02.00 CONSENTED VS. PROPOSED DRAWINGS
02.07 (NORTH) EAGLE STREET ELEVATION

Planning Application 2020/1350/P

Planning Application 2021/3561/P

02.07 (NORTH) EAGLE STREET ELEVATION

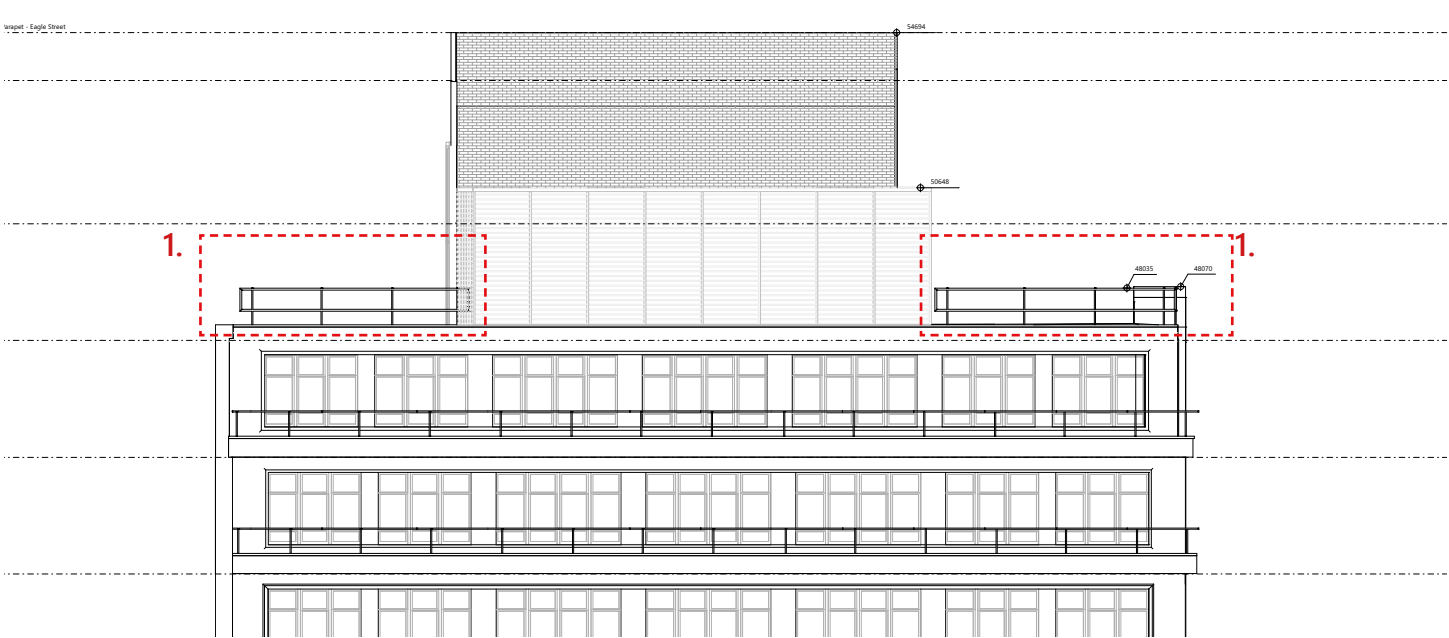
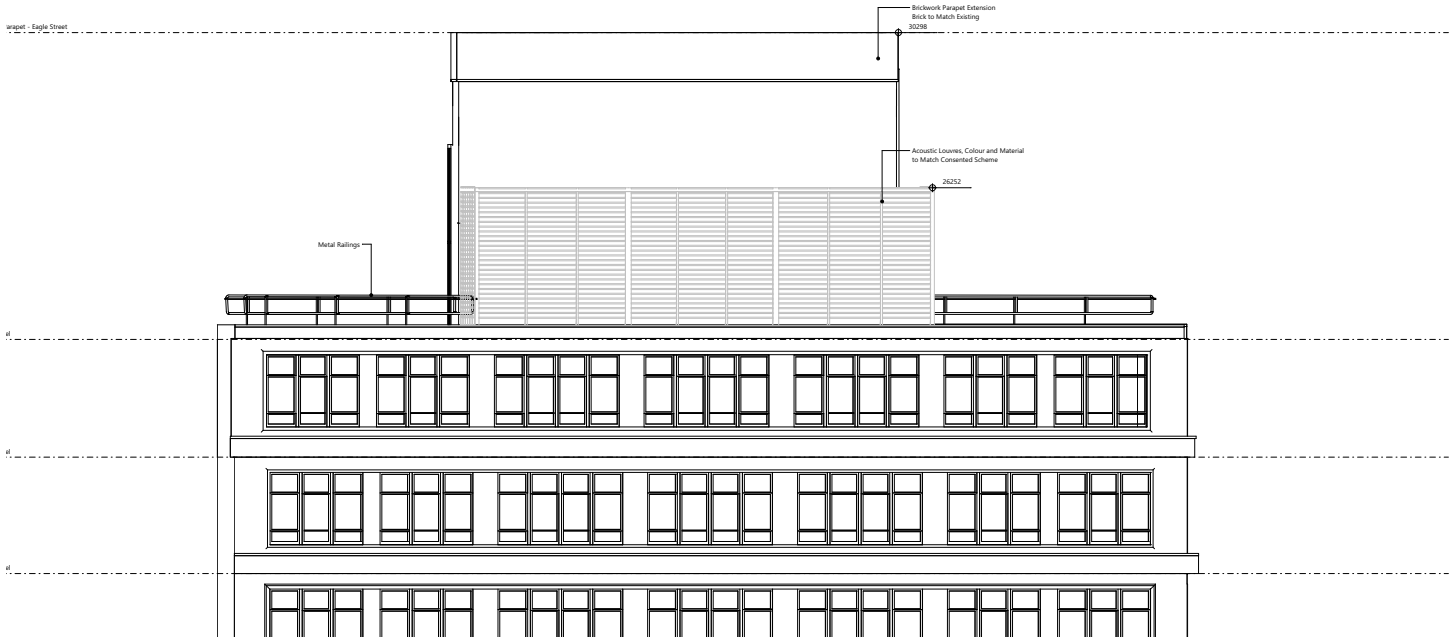
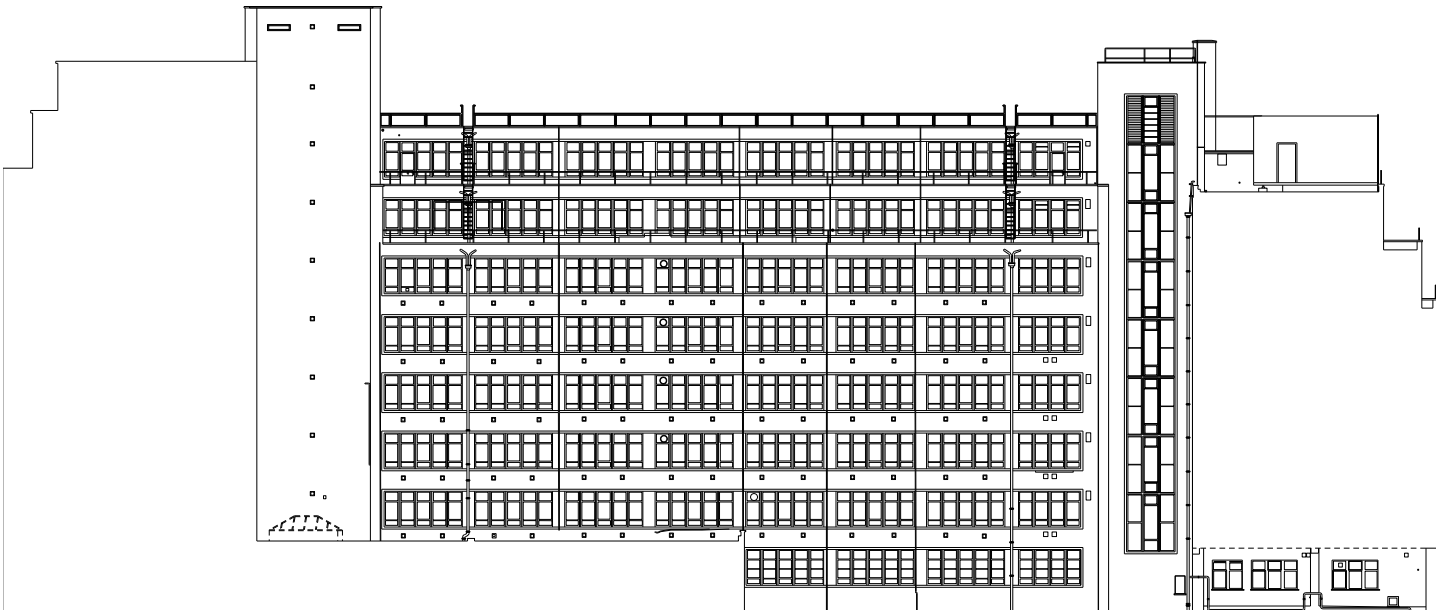
1. Replacement railing to match existing. In order to comply with Part L building regulations, all roofs will receive new coverings which will improve their thermal performance. The consequent increase in the roof build up means that the railings will no longer be Part K compliant as they will be less than 1.1m above external finish floor level. As the existing railings do not guarantee safe access to the roofs, the proposal is to replace these by new ones which will rise a least 1.1m above the external roof level.

02.00 CONSENTED VS. PROPOSED DRAWINGS
02.08 EAST ELEVATION

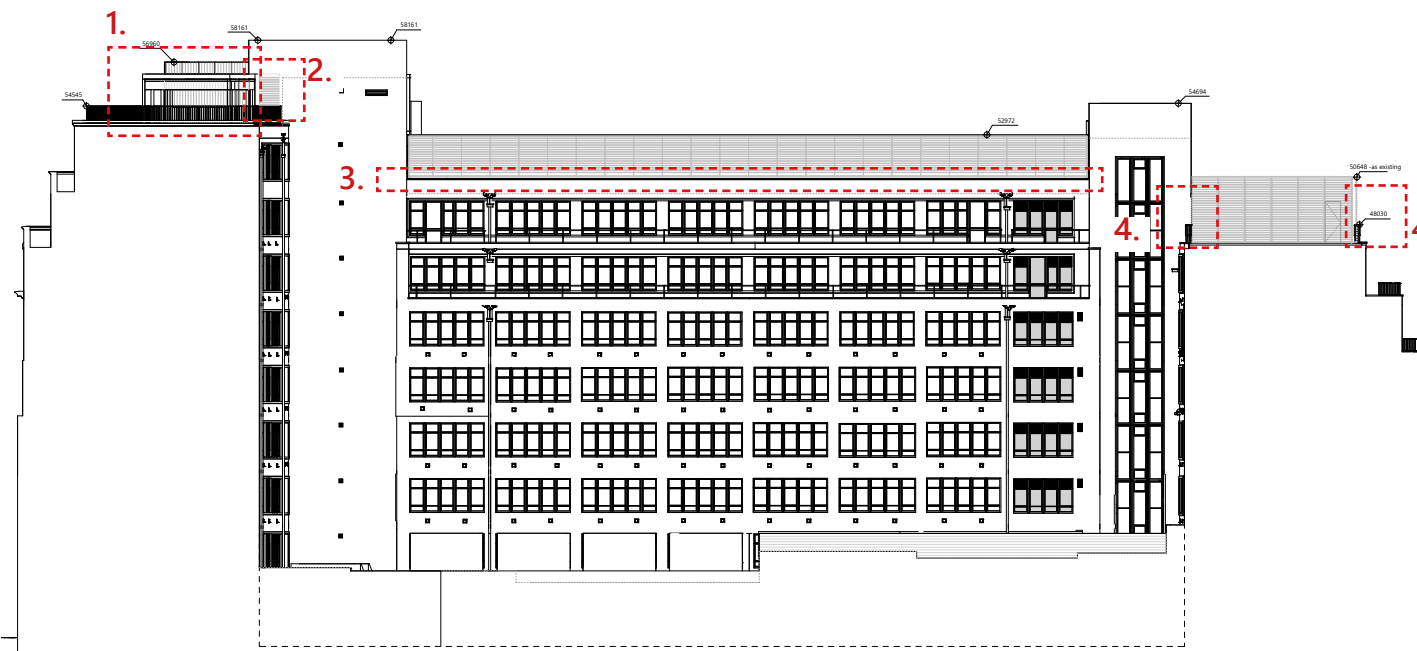
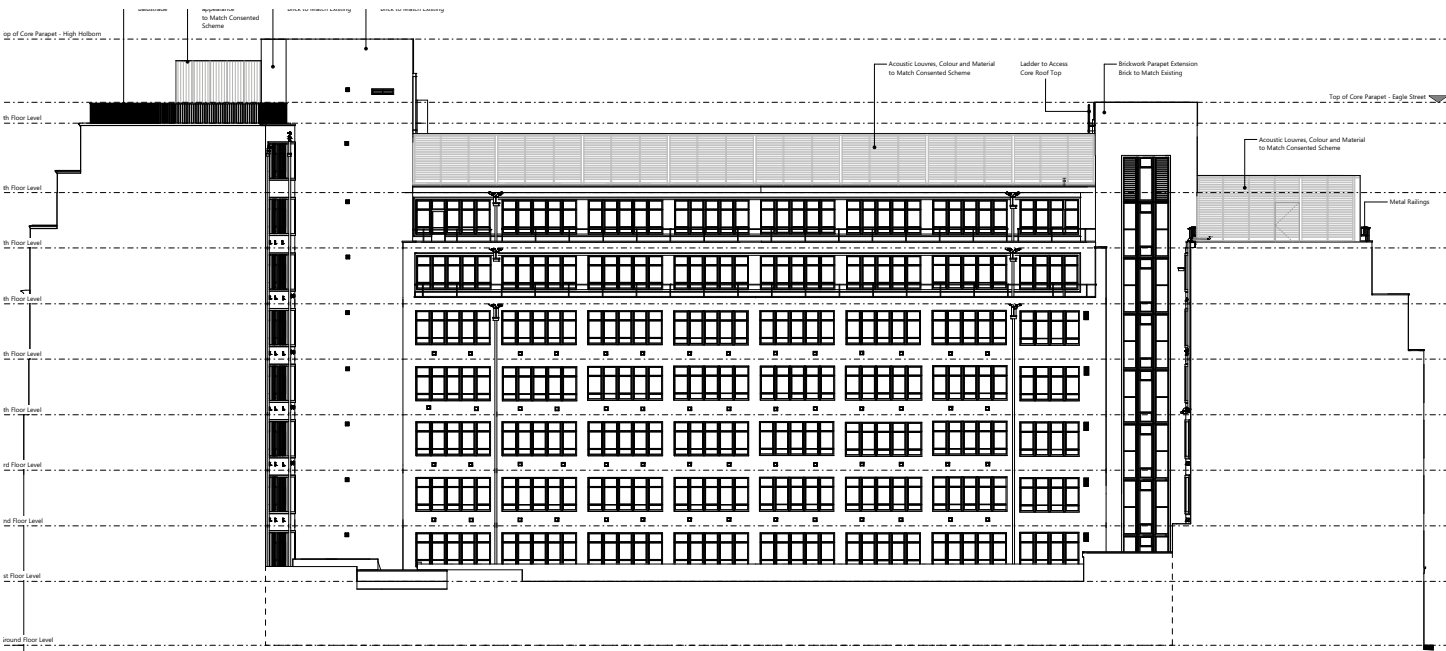
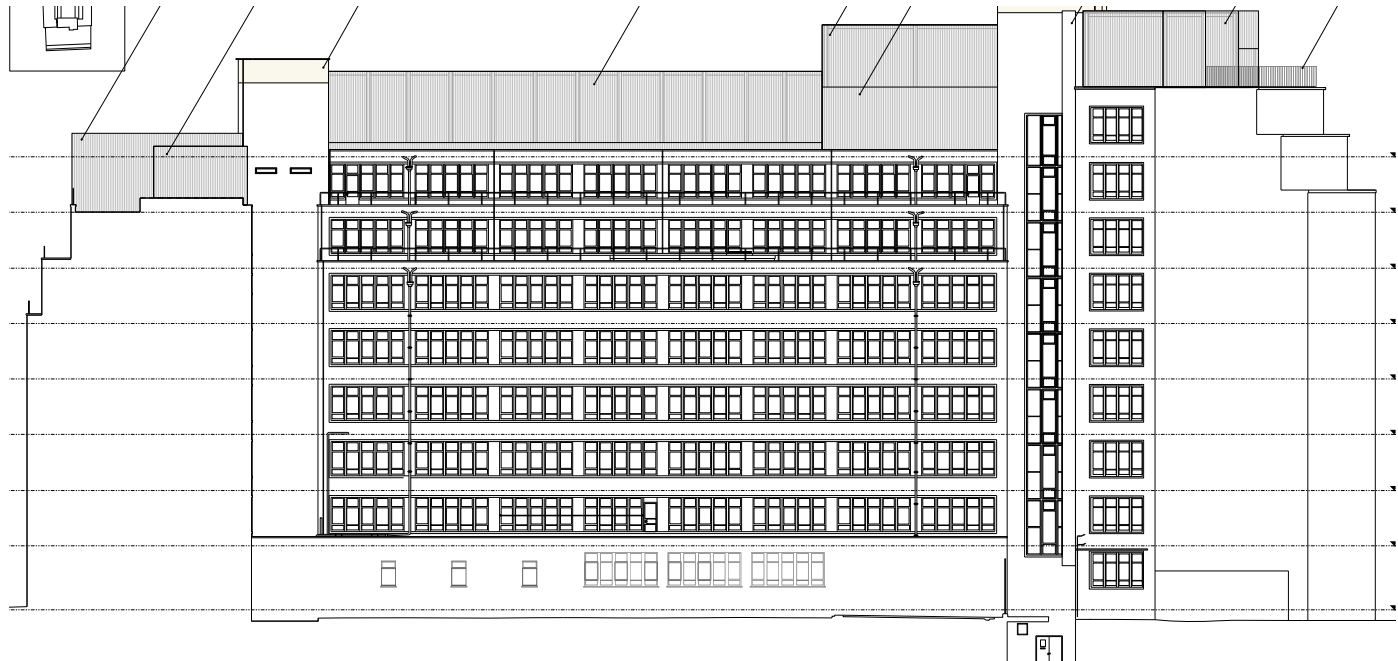
1. Covered area to be extended through a lightweight pergola structure as previously consented (2020/1350/P). Pergola structure to have a PPC finish, colour to match the metal cladding of the roof extension.
2. Louvres required on the side walls of the new brick walls of the previously consented roof extension.

3. Parapet of link block roof extended to accommodate overall roof build up (strengthening of existing slab and insulation for improved thermal performance). Brick to match existing.

4. Replacement railing to match existing. In order to comply with Part L building regulations, all roofs will receive new coverings which will improve their thermal performance. The consequent increase in the roof build up means that the railings will no longer be Part K compliant as they will be less than 1.1m above external finish floor level. As the existing railings do not guarantee safe access to the roofs, the proposal is to replace these by new ones which will rise a least 1.1m above the external roof level.

02.09 WEST ELEVATION

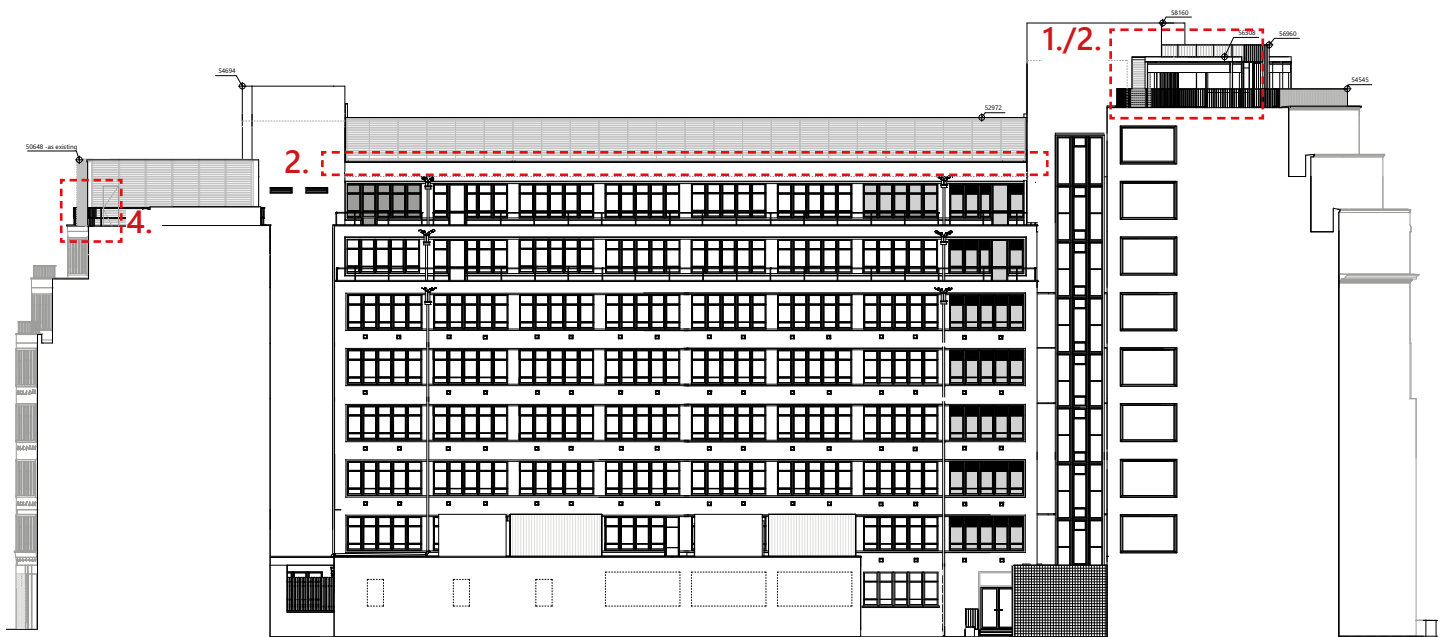
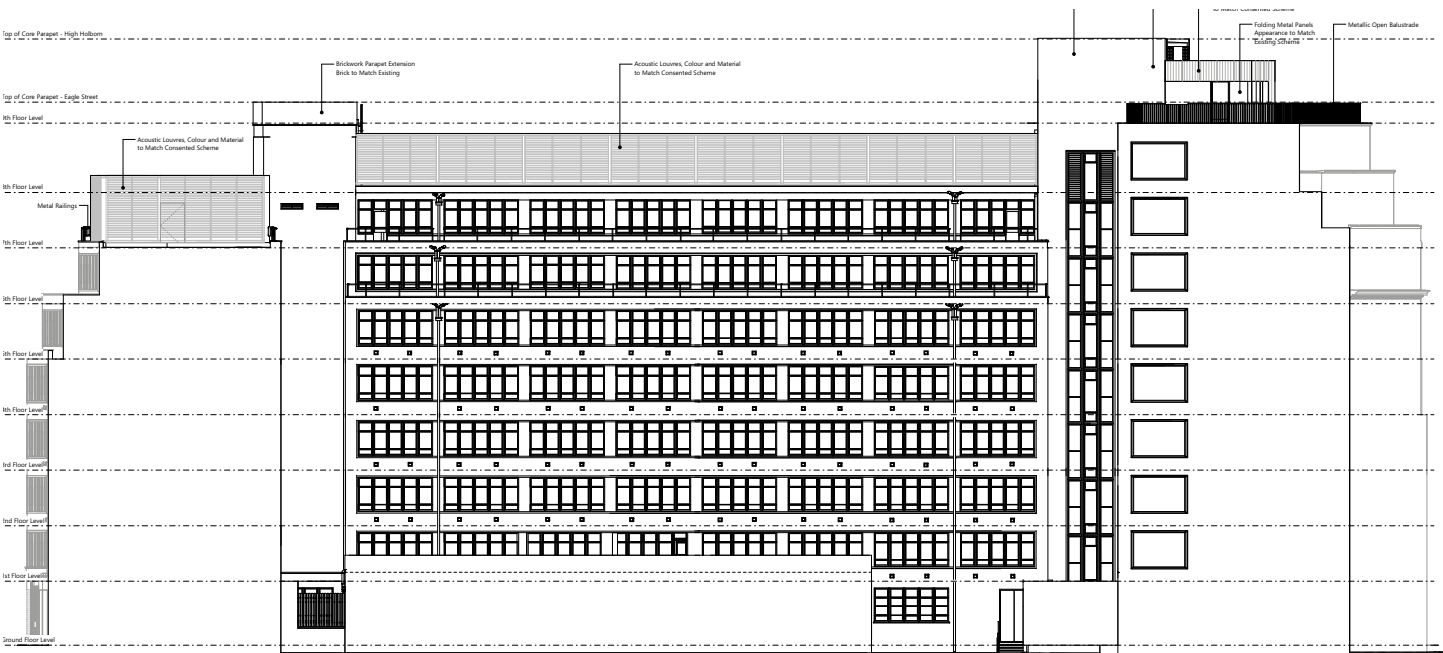
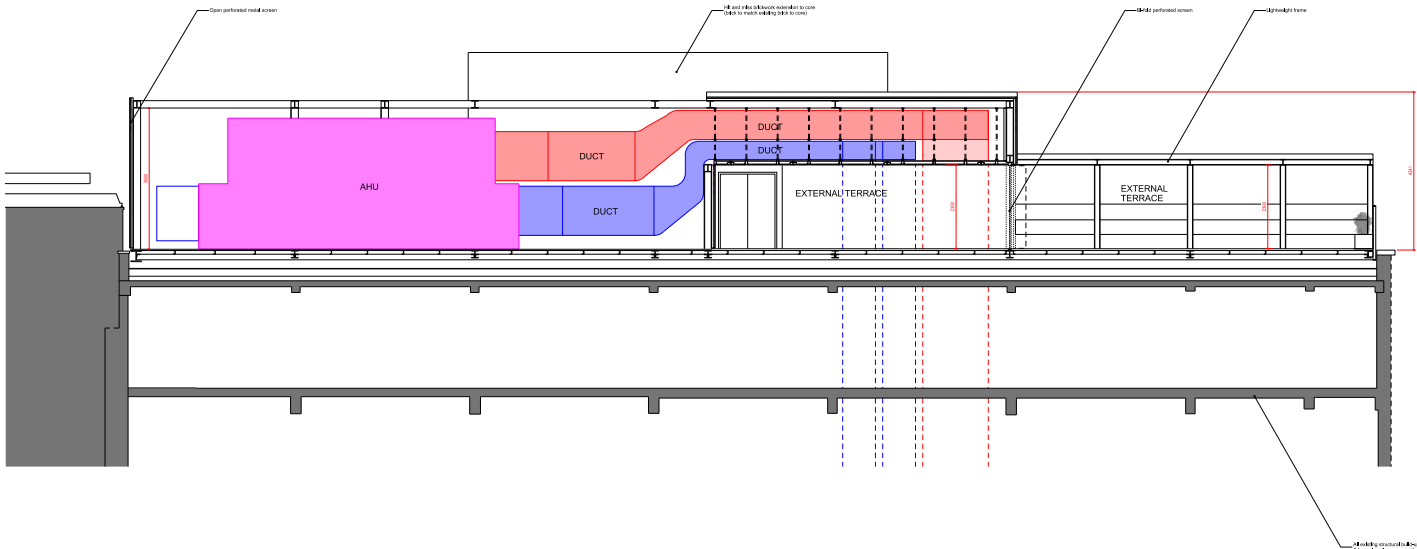
1. Covered area to be extended through a lightweight pergola structure as previously consented (2020/1350/P). Pergola structure to have a PPC finish, colour to match the metal cladding of the roof extension.
2. Louvres required on the side walls of the new brick walls of the previously consented roof extension.

3. Parapet of link block roof extended to accommodate overall roof build up (strengthening of existing slab and insulation for improved thermal performance). Brick to match existing.

4. Replacement railing to match existing. In order to comply with Part L building regulations, all roofs will receive new coverings which will improve their thermal performance. The consequent increase in the roof build up means that the railings will no longer be Part K compliant as they will be less than 1.1m above external finish floor level. As the existing railings do not guarantee safe access to the roofs, the proposal is to replace these by new ones which will rise a least 1.1m above the external roof level.

02.10 SECTION AA

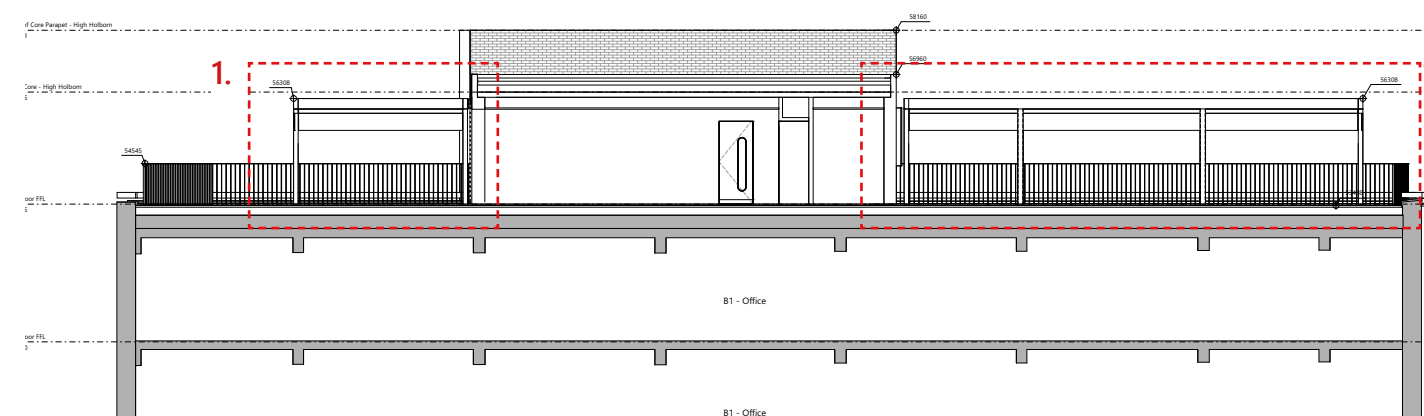
1. Covered area to be extended through a lightweight pergola structure as previously consented (2020/1350/P). Pergola materiality and colour to be as per originally consented scheme (2020/1350/P). Pergola includes integrated blinds for additional thermal and weather protection.
